PREVOST

**WARRANTY
BULLETIN**

Wb09-15

DATE : OCTOBER 2009	SECTION : 16 - Suspension
EXPIRATION: OCTOBER 2010	
SUBJECT : PANHARD ROD SUPPORT WELD BEAD VERIFICATION

FIGURE 1

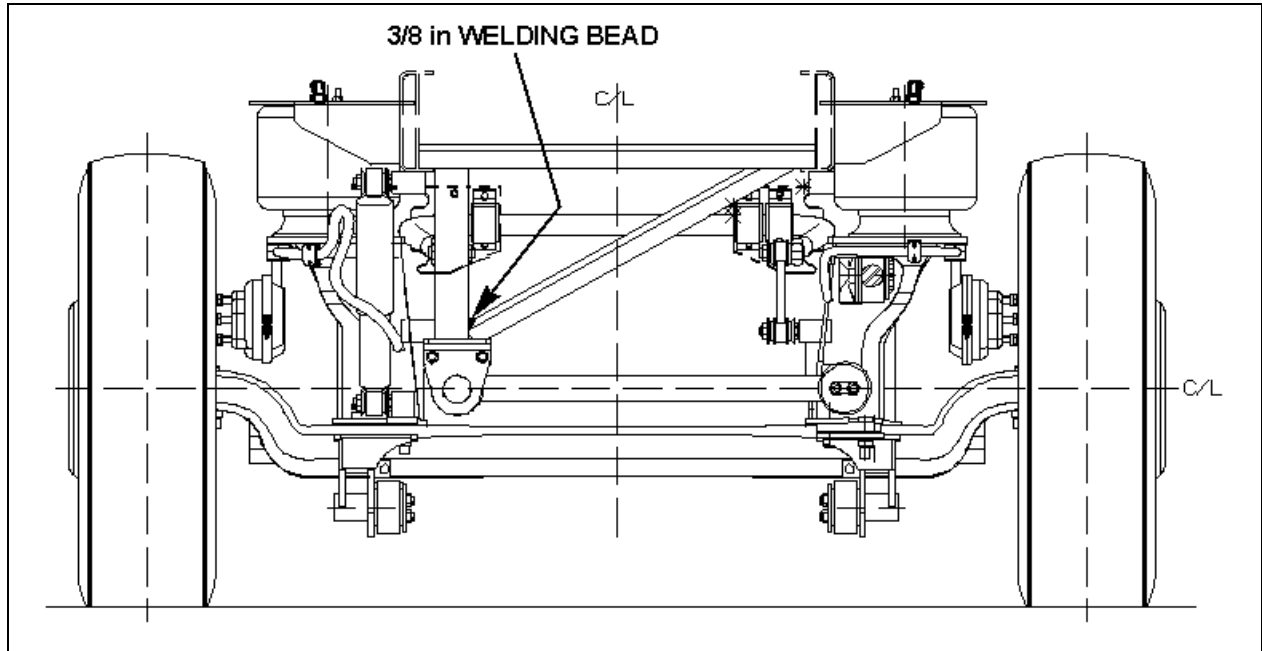
Check size of weld bead located between Panhard rod support vertical tubing and C-channel.

Size of weld bead must be 3/8 in (10 mm) minimum (Refer to figures 1, 2 and 3).
